**Re: Response to Preliminary Geologic/Seismic Hazard Review and
Supplemental Geologic Investigation
Proposed Senior Housing Facility
4200 Dove Hill Road
San Jose, California
Langan Project No.: 770619902**

This letter presents our response to review comments by the San Jose Department of Public Works (SJDPW) dated 25 September 2015 regarding our Geotechnical Investigation and Geologic Hazard Evaluation report dated 30 June 2015 for the proposed senior Housing Facility project at 4200 Dove Hill Road in San Jose, California. SJDPW had several comments (designated 1 through 13 in their review letter) regarding geologic/seismic hazards evaluation and mitigation at the site; a copy of the review letter is included in Appendix D. The project will consist of two new buildings, designated as Buildings A and B; both buildings are proposed to be four stories above a podium level as shown on Figure 1.

DOVE HILL ASSISTED LIVING COMMUNITY
4200 DOVE HILL ROAD
 San Jose, California
SLOPE STABILITY ANALYSIS
IDEALIZED SUBSURFACE PROFILES
1-1', 2-2', 3-3', AND 4-4'
EXISTING CONDITIONS

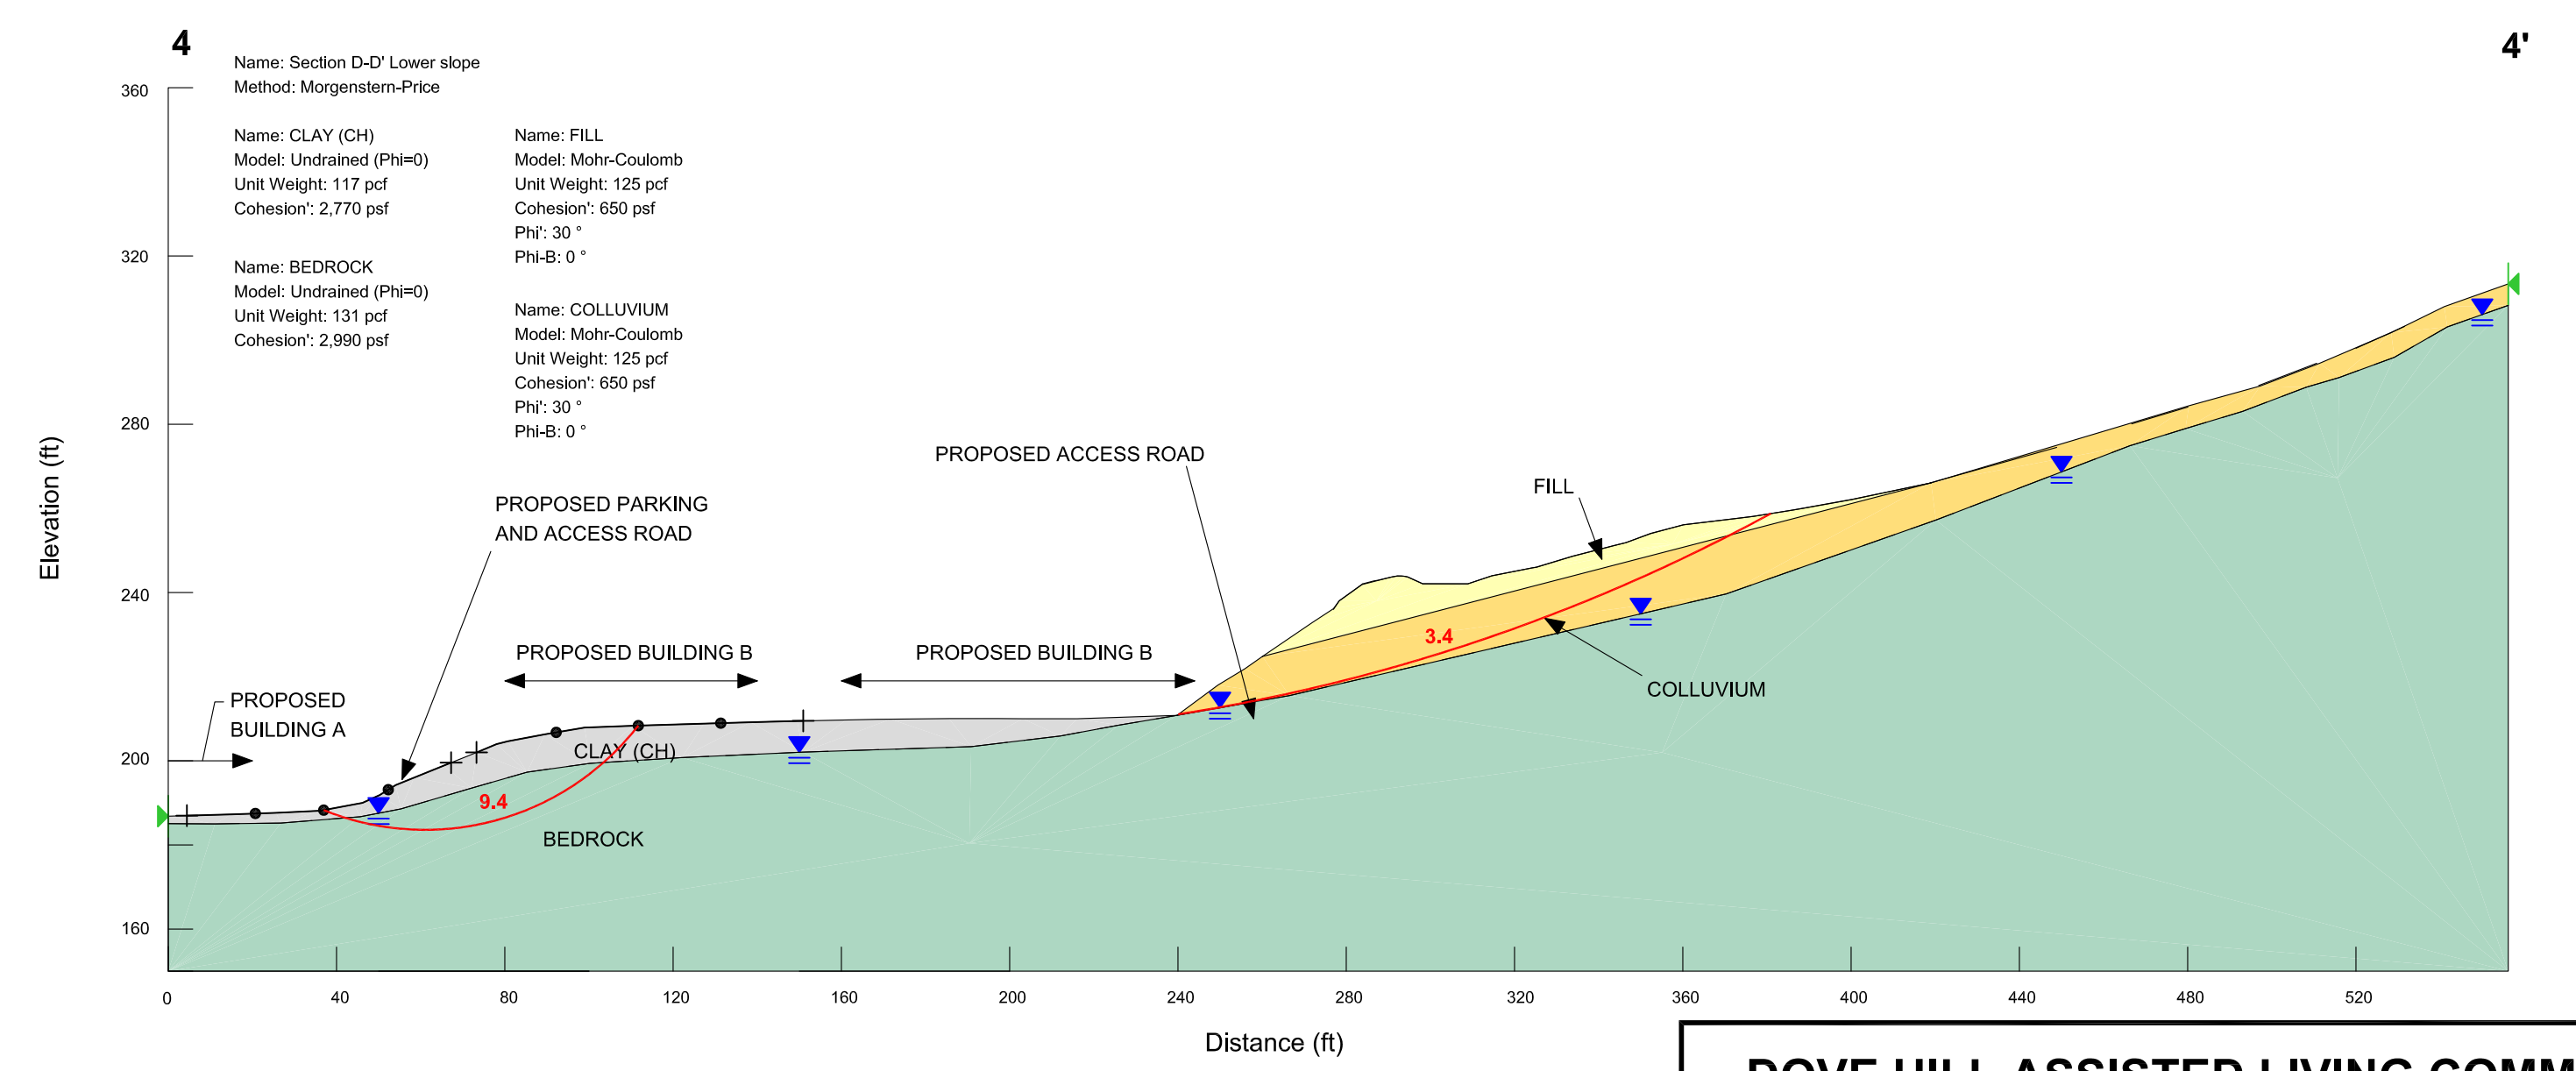
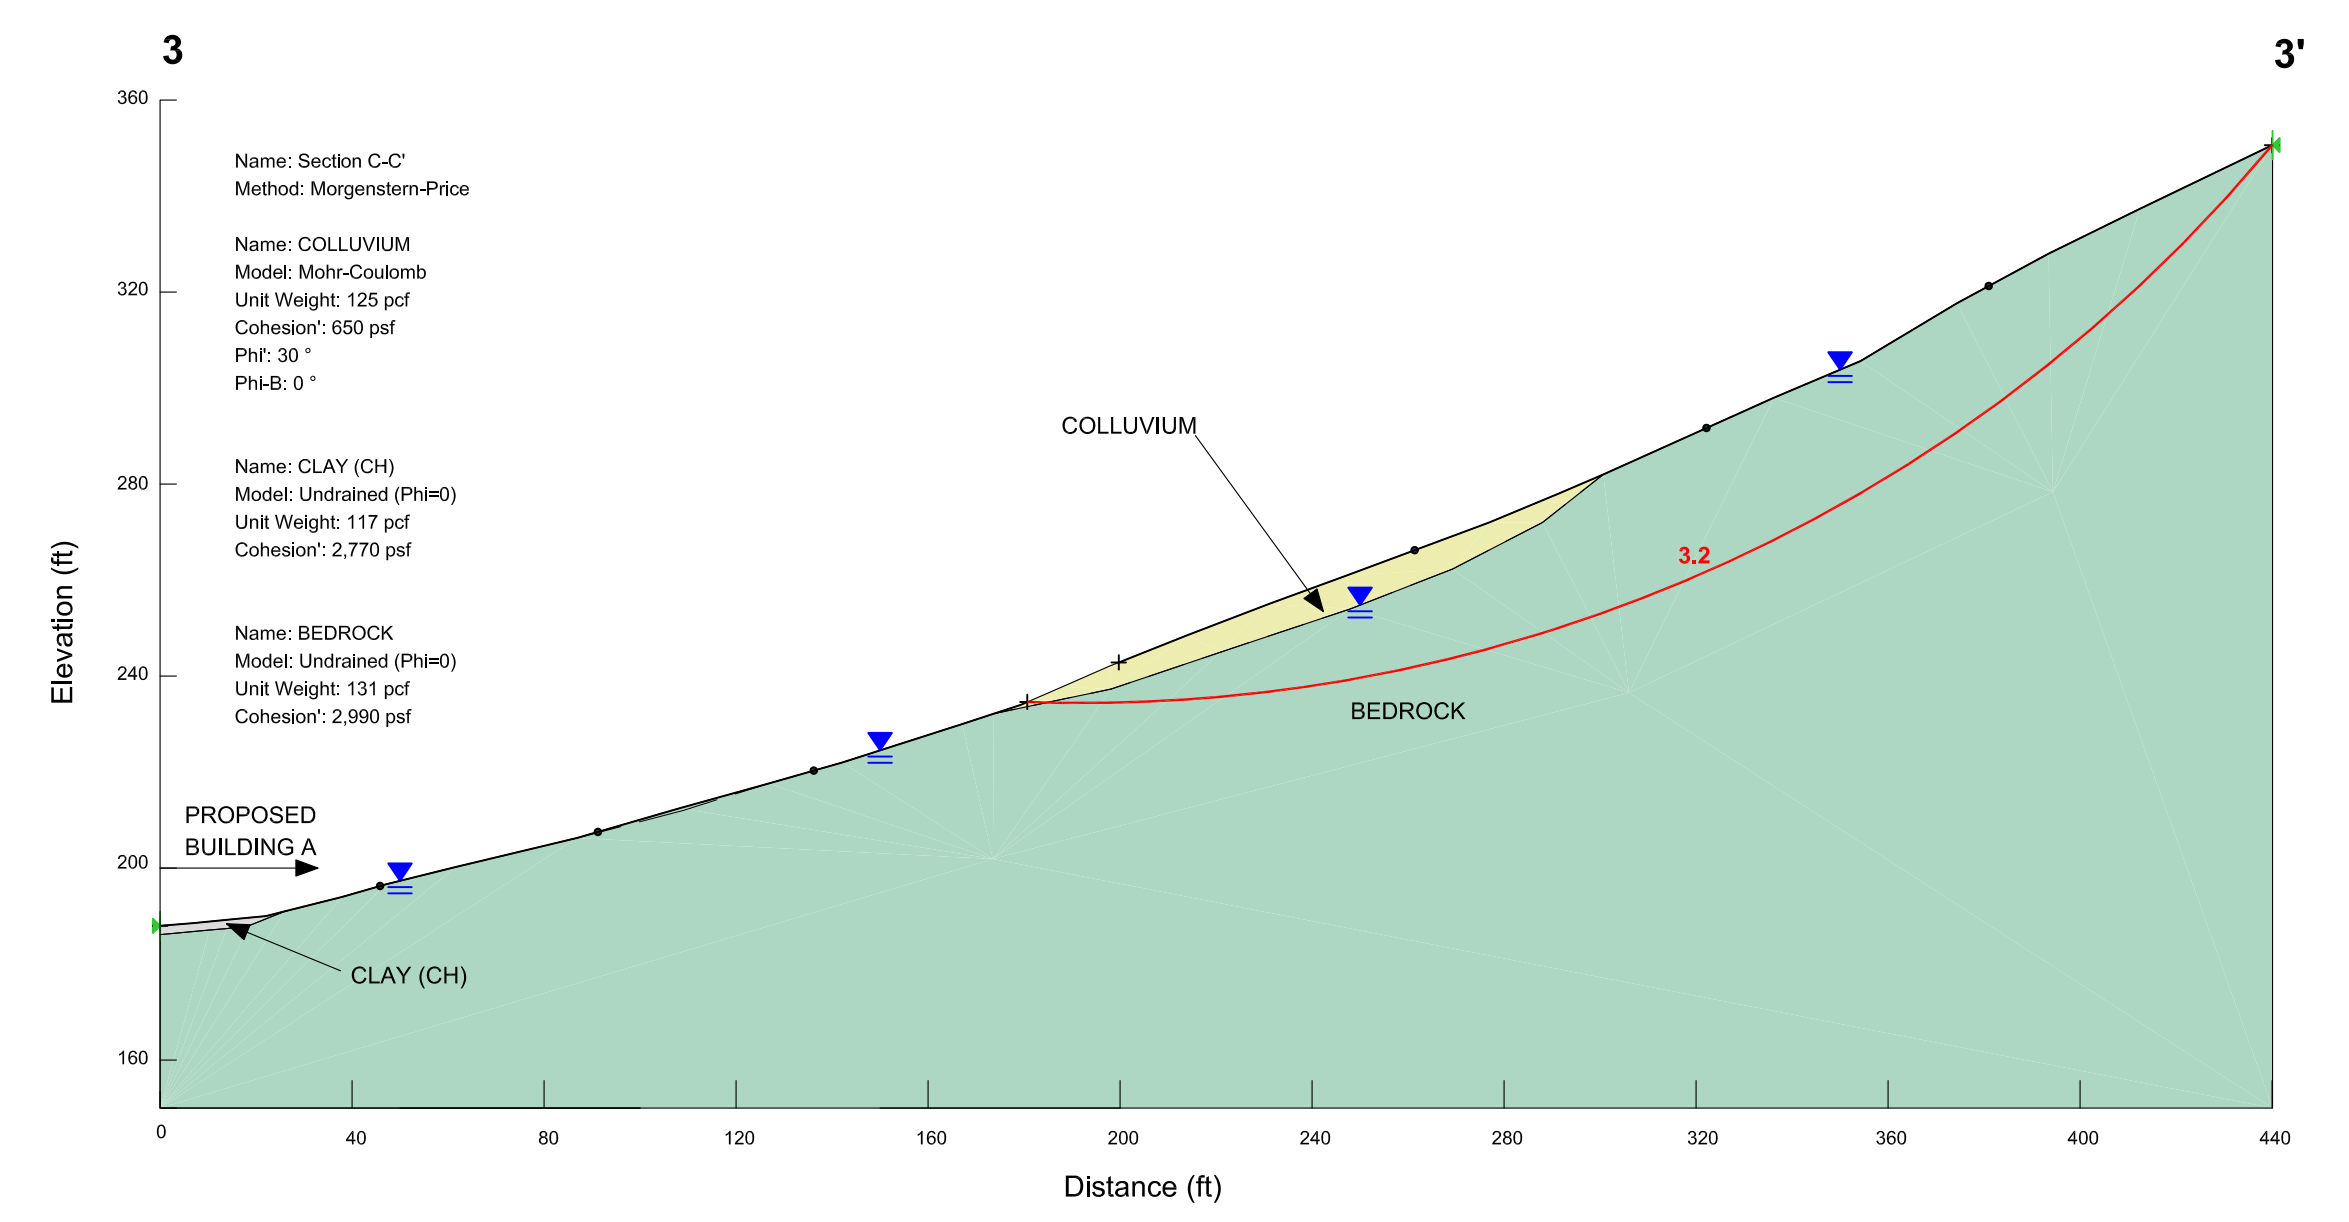
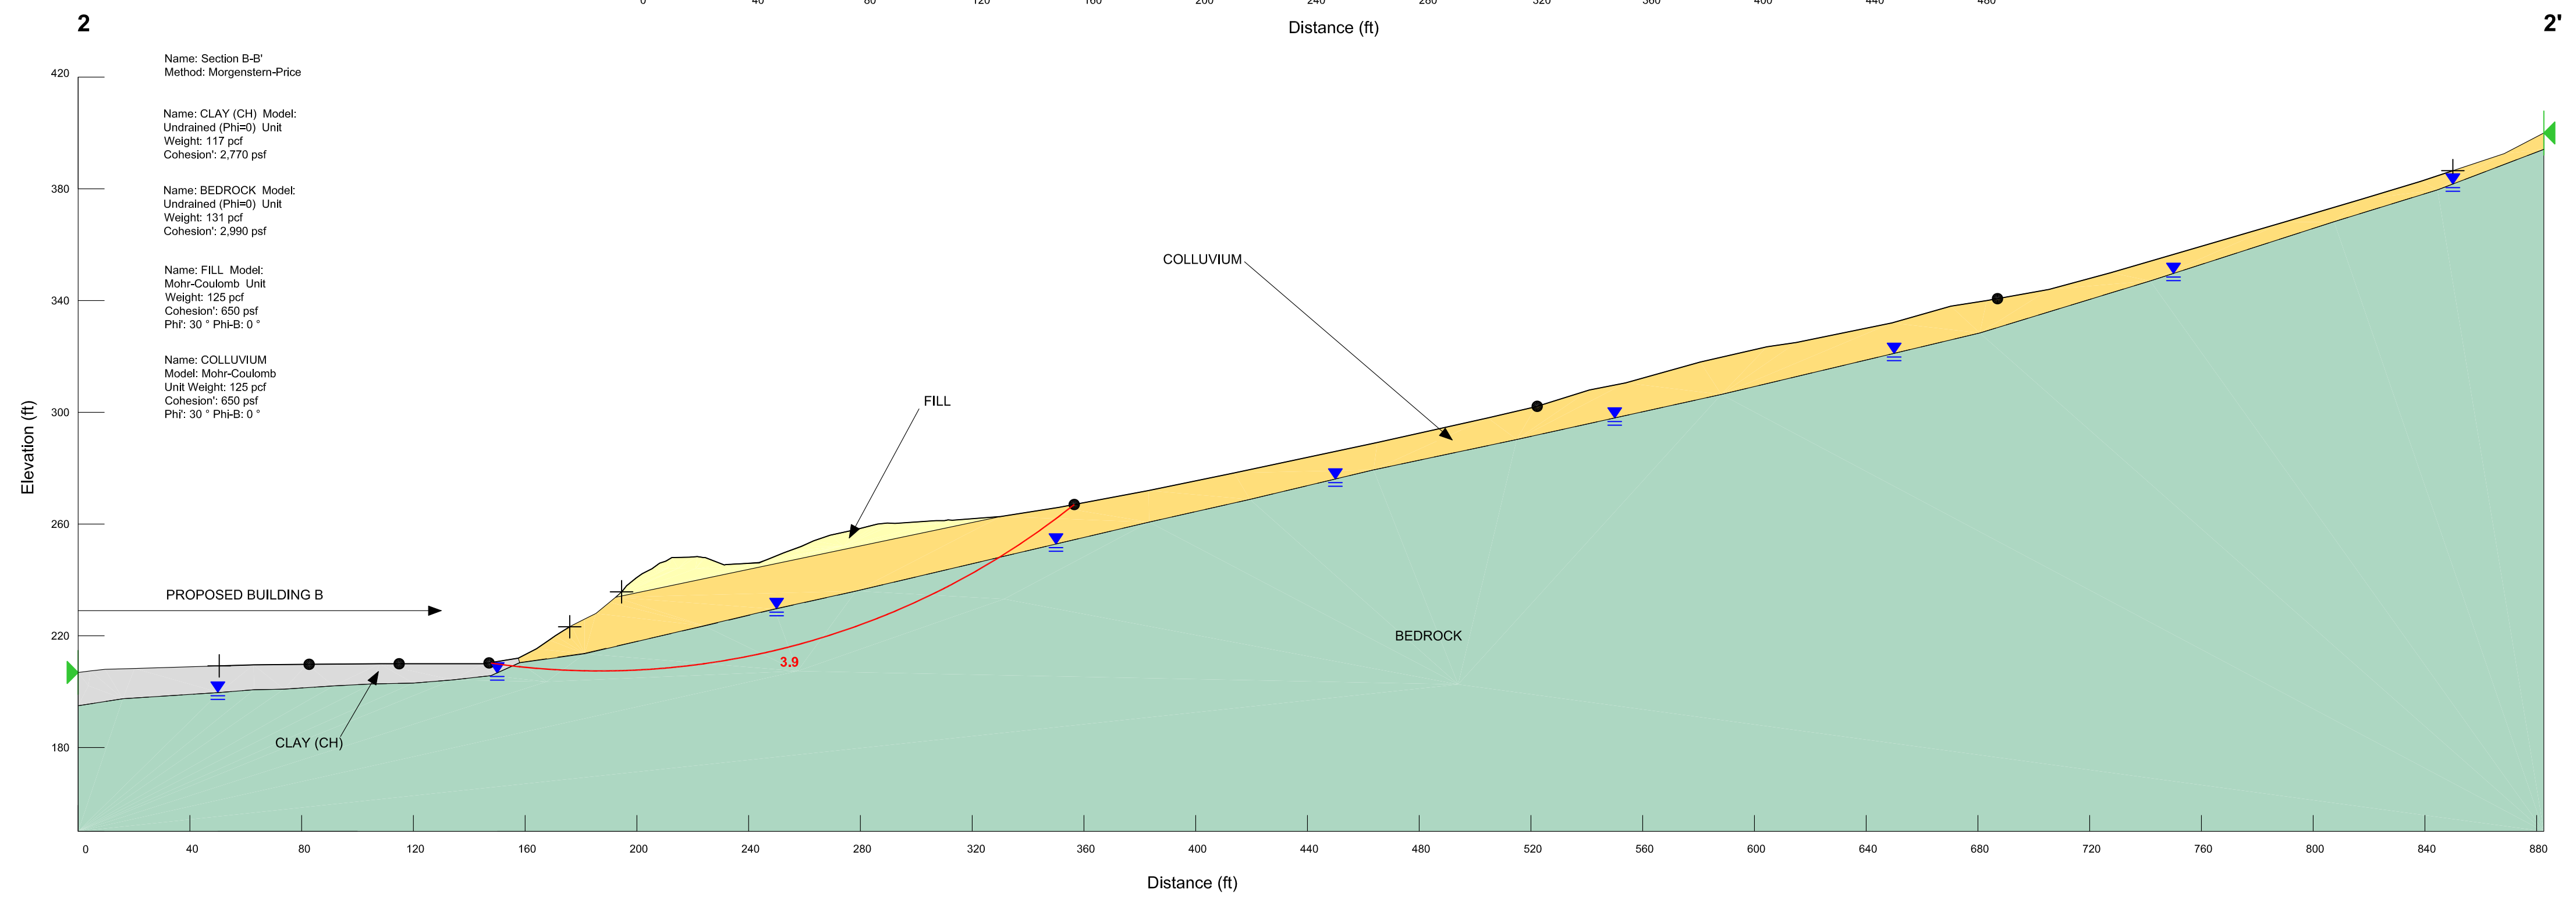
SJDPW was concerned that the existing landslides on the northern and southern slopes of the site could mobilize and impact the proposed development under potential high groundwater seepage conditions. SJDPW requested that the landslides be characterized in greater detail and evaluated under these conditions.

The results of the slope stability analysis of Section 3-3' showed a static factor of safety of less than 1.5 and slope displacement of about 4 inches. SJDPW recommended that the stability of cross section 3-3' be reevaluated based on the supplemental subsurface exploration and potentially high groundwater levels.

We have analyzed the slope stability on the site using the newly acquired data. In our initial evaluation we conservatively modeled the groundwater along the surface of the bedrock, however we did not portray this on our figures. The location of the critical slope failure surfaces and the location of the modeled groundwater surface for each of the profiles evaluated are provided on Figures 4 (current conditions) and 5 (proposed grading)/.

The results of our analyses indicate most of the existing slopes are stable or may exhibit negligible permanent slope displacements upslope of the proposed improvements during a major earthquake. However, the landslide deposits above proposed Building B could exhibit significant permanent slope displacements, if not removed and regraded, as previously discussed. The results of our slope stability analyses and seismic slope displacements are summarized in Table 2, below for existing conditions. We used the same methodology to evaluate slope stability and potential slope deformations during a seismic event as discussed in our previous geotechnical report. The location of the critical slope failure surfaces for each of the profiles evaluated showing existing conditions are provided on Figure 4.

See response to comments 1 and 4 for additional details concerning the supplemental subsurface exploration, groundwater conditions, and results of the slope stability analyses. The location of the critical slope failure surfaces and the location of the modeled groundwater surface for section 3-3' are provided Figures 4 and 5.
